AUBURN HILLS COMMERCIAL ADDITION

FINAL PLAT

RE: S/D 96-34, Final Plat of the AUBURN HILLS COMMERCIAL ADDITION

RE: S/D 96-34, Final Plat of the AUBURN HILLS COMMERCIAL ADDITION

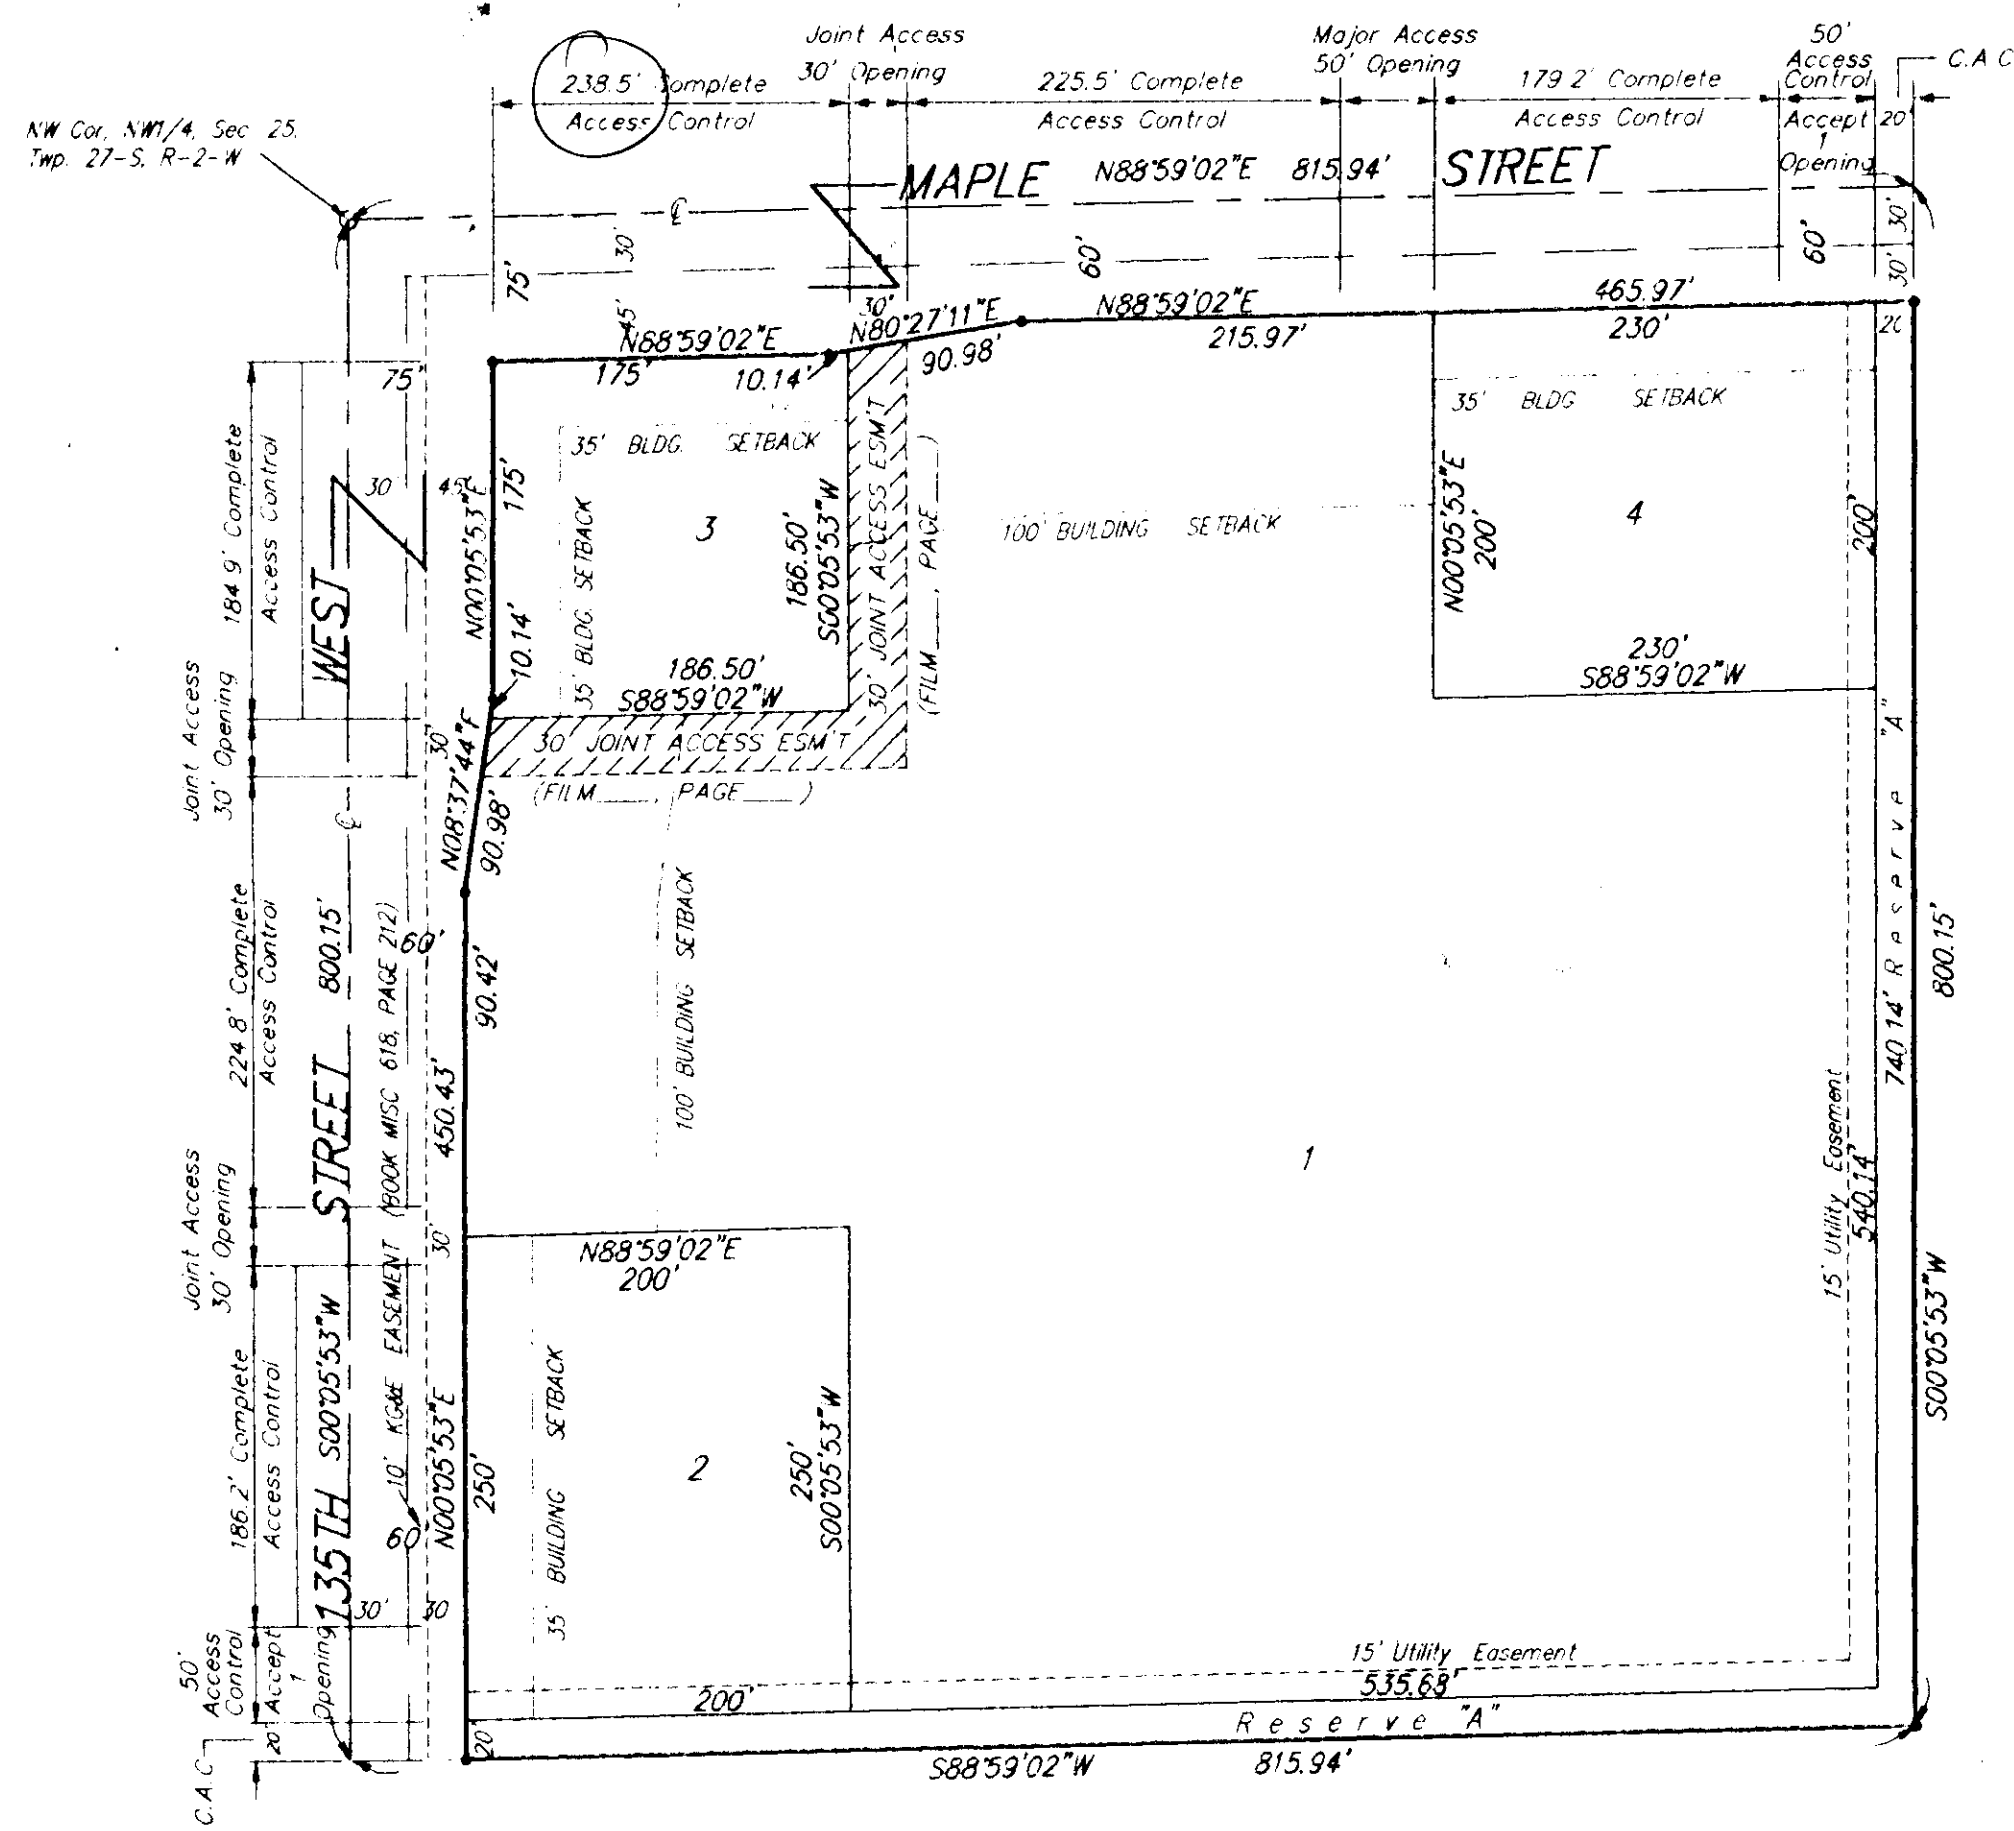
- ✓ A. The applicant shall guarantee the extension of sanitary sewer to serve the lots being platted. The final plat tracing shall also indicate easements for sanitary sewer to serve Lots 2 and 3. As noted by City Engineering, the applicant needs to finalize with the County agreements for the use of the County's sewer lines in this area.

- ✓ B. The applicant shall guarantee the extension of City water to serve the lots being platted. This guarantee shall include needed extensions along 135th Street West adjacent to this site.

- ✓ C. The applicant shall guarantee any drainage improvements required by the platting of this property. Such improvements may be done privately at the time of site development, but all such improvements shall be outside of any public easement. A cross-lot drainage agreement shall, however, be submitted for this site.

- ✓ D. As noted by CUP, DP-219, the following improvements shall be guaranteed:
 - 1. An accel-decel lane around the corner of the intersection to the major opening at Maple.

- 2. A left-turn lane in Maple to serve the major entrance.
 - 3. Permanent paving of 135th Street West adjacent to this site. ✓
 - 4. That portion of the major entrance at Maple located in the area of public right-of-way.

- F. Since Lot 3 will not have direct access to a public street from its frontages to Maple and

135th Street West, but will instead use joint access easements, the applicant shall submit for recording with the plat, such joint access easement. This easement should note which property(s) are benefitting from the easement, that such easement cannot be encumbered and who or how the easement will be maintained.

- I. Since this site has been annexed to the City, County Commission approval of the plat is not required. On the final plat tracing, the County Commission's signature block shall be deleted.

- P. As requested by the applicant, the final plat tracing may revise (expand) Lot 3. However, prior to the plat being scheduled for City Council review, any needed adjustments to the CUP shall be obtained in regard to such a change. As necessary, the final plat tracing will also adjust any platting items effected by such a change.

- Q. As noted by Traffic Engineering, the dimensions indicating access controls to the adjacent arterials need to be corrected for the final plat tracing.
- R. Prior to this plat being scheduled for City Council review, a revised drainage plan shall be submitted to and approved by City Engineering. Off-site detention appears necessary and appropriate calculations shall be provided for such drainage.
